SOURIAU

Subject: Product Change Notification

RMDX60-_____ Series
RCDX60-_____ Series

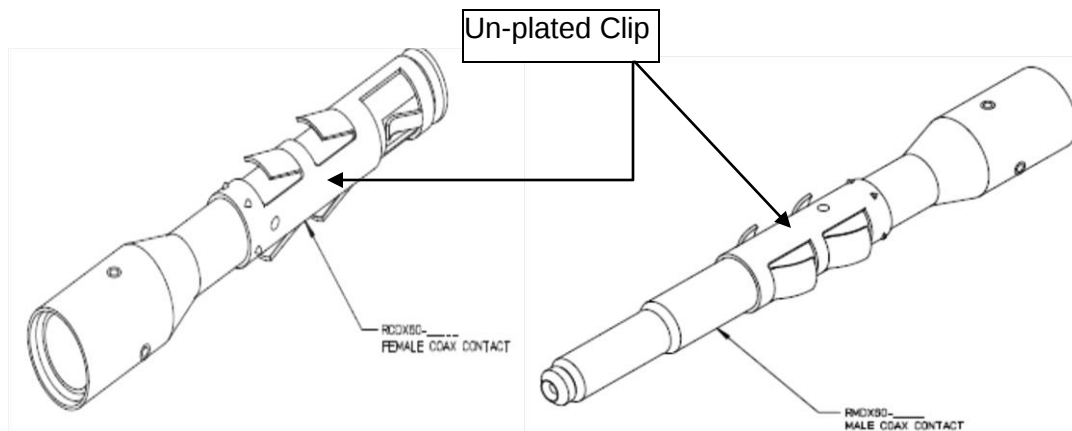
Plating will be eliminated from the retention clip of the contact.

The change eliminates a non-value add operation.

There is no impact on the final fit and function of the part in usage. The form will be changing slightly and will be observed in the contact clip coloration. The change has no impact on the performance of the part. This component serves no electrical function and therefore will not impact electrical performance. The mechanical structure of the component is determined by base material and therefore it will maintain existing retention features.

Implementation will be phased in as existing inventories are exhausted in the distribution and inventory pipeline. All product will be shipping in new format on July 1st 2012.
